**WOKINGHAM
BOROUGH COUNCIL**

Approval of Reserved Matters Consultation

Site Address: Land To West Of Park Lane, Charvil, RG10 9TS

Proposal: Application for approval of Reserved Matters pursuant to Outline Planning Consent 232704 comprising details of 75 homes, together with associated internal access roads, parking, public open space, landscaping and sustainable drainage systems (SuDS). Details of appearance, landscaping, layout and scale to be considered.

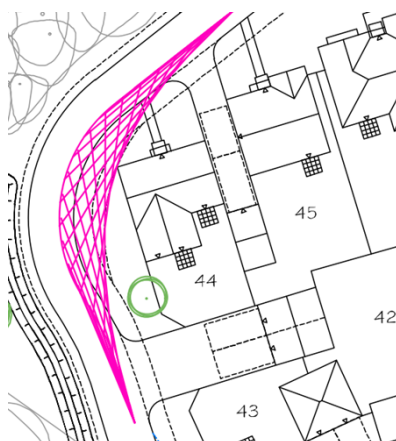
2. Any amended drawings submitted should display the proposed carriageway dimensions and corner radii across the site layout. The drawings should include a scale bar.

- a. **19.06.2026:** This point is considered addressed by the LHA. Drawing ITS210467-GA-001 has been updated to show additional dimensions and corner radii.

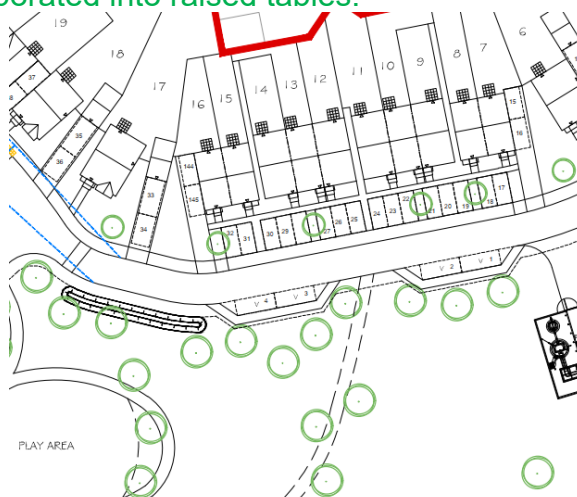
6. Tabled crossings would be welcomed in locations where crossings are needed. An additional uncontrolled crossing should be provided to the play area where a path is shown between the visitor parking spaces:

- a. **19.06.2026:** The LHA consider this point addressed. Crossings are now incorporated into raised tables.

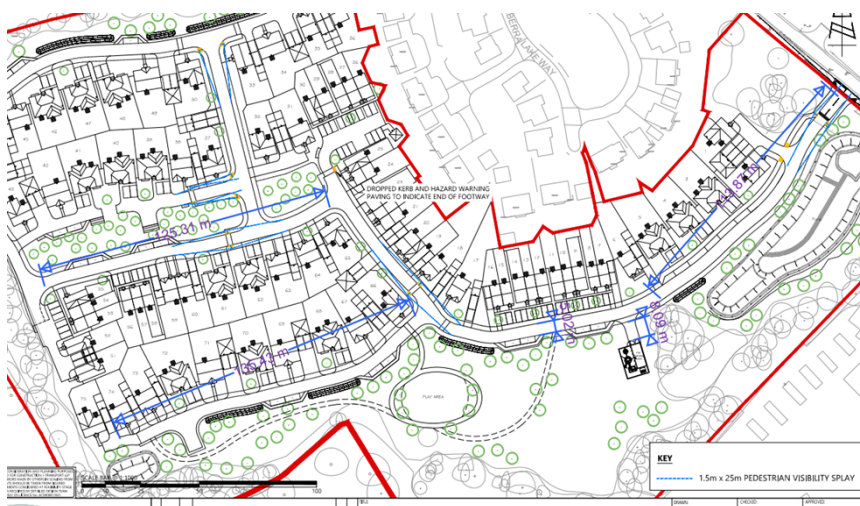
7. DfT LTN1/07 *Traffic Calming* advises that 'Speed control measures should be spaced at about 60 to 70 metres apart but not more than 50 metres from any given point unless on cul-de sacs less than 80 metres long...this spacing of traffic calming measures should ensure that the zone is self-enforcing (i.e. vehicle speeds are kept at least at or below an average of 20mph' (Paragraph 3.2.17). A screenshot is provided below highlighting the longer street sections which require speed reduction features:

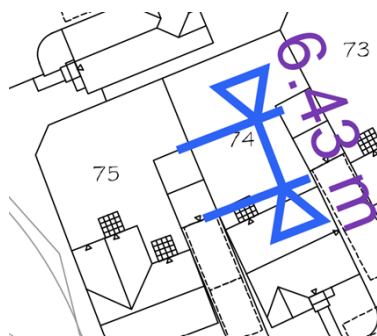
18. The LHA require parking spaces (and garage) outside numerous plots to be pulled further forwards closer to the carriageway. This includes Plot 6, Plot 7, Plot 42, Plot 43, Plot 44, Plot 49, Plot 64, 65, Plot 66, Plot 67, Plot 69, Plot 71, Plot 73 and Plot 74.
 - a. **19.06.26:** The LHA are satisfied that this point is addressed by the applicant.
19. These dwellings appear to have excess driveway space between their parking spaces and the proposed carriageway; which could result in

residents attempting to squeeze in additional parked cars and could result in parked cars overhanging the footway.

20. Otherwise, there is space in front of spaces which could result in use as informal parking spaces (but may not be large enough for a car) and this could result in vehicles overhanging the footway and encourage higher levels of car ownership/parking.

21. Some examples are provided below:
